Request for Four Class 2 Permit Modifications

Los Alamos National Laboratory Hazardous Waste Facility Permit
Public Information Meeting

May 2007

LA-UR-07-3121

Third proposed modification

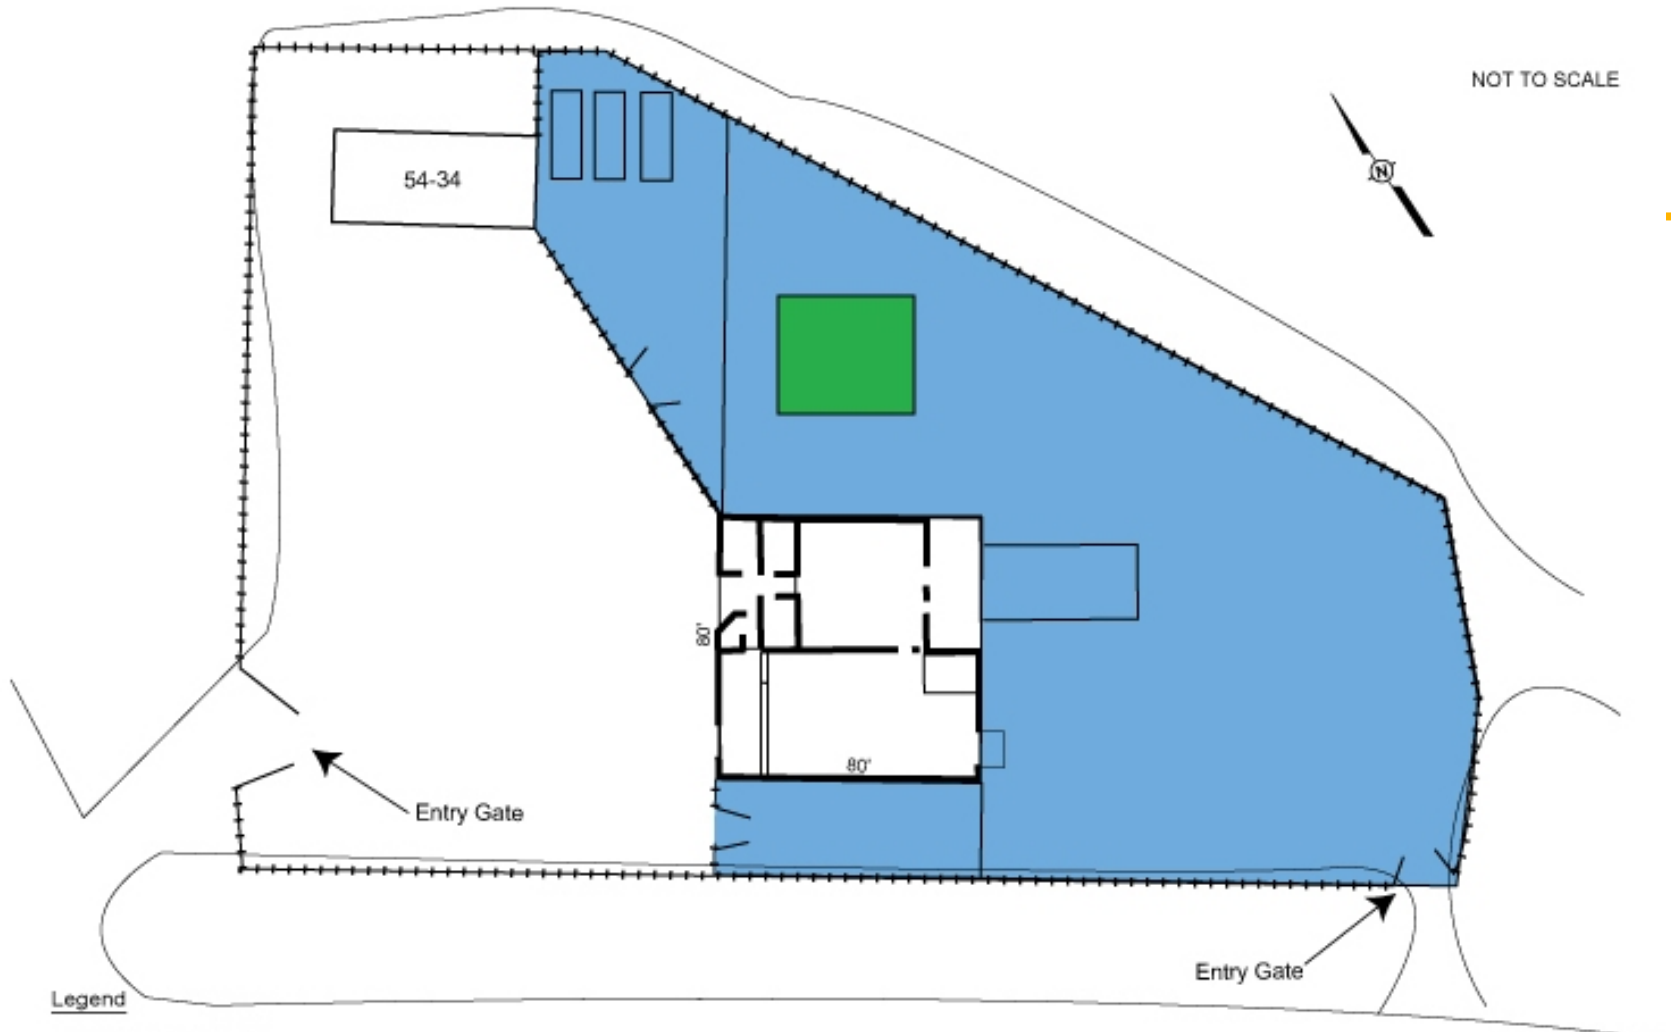
- Footprint change for the outside container storage unit at TA-54 West.
- Allow for storage within modular buildings or transportainers, temporarily in payload configurations and within loaded waste trucks prior to transport.
- Improves efficiency, resolves transport issues, and increases the opportunity for covered storage within the bermed fenced area at TA-54-38.
- Does not increase the amount of waste that can be stored in the unit or change the types of wastes stored at the area.

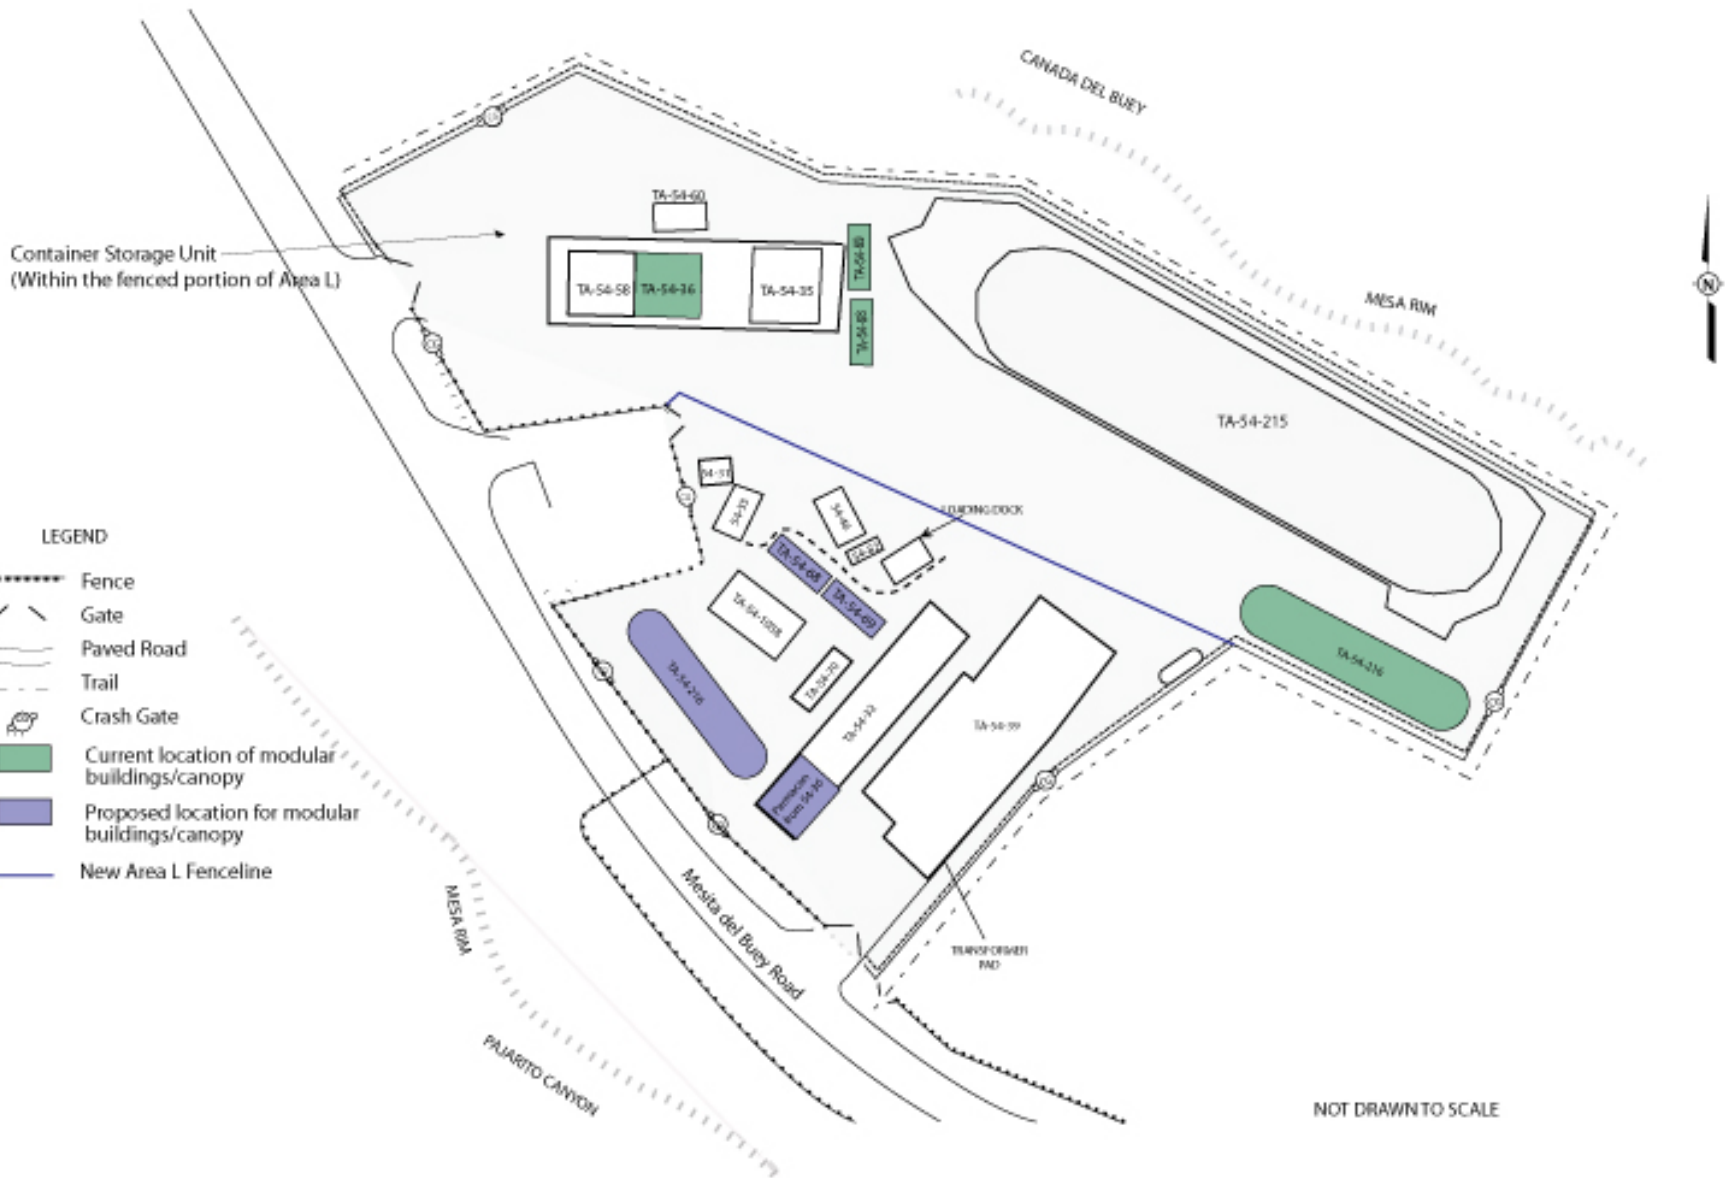
- Movement of modular buildings and a canopy from the north side of TA-54, Area L to the south side.
- Enables the closure and corrective action activities of the land disposal units at TA-54, Area L while waste storage activities continue.
- Does not increase the amount or change the types of wastes to be stored at TA-54, Area L.
- Modification is requested to be applied to LANL's permit renewal application documentation.
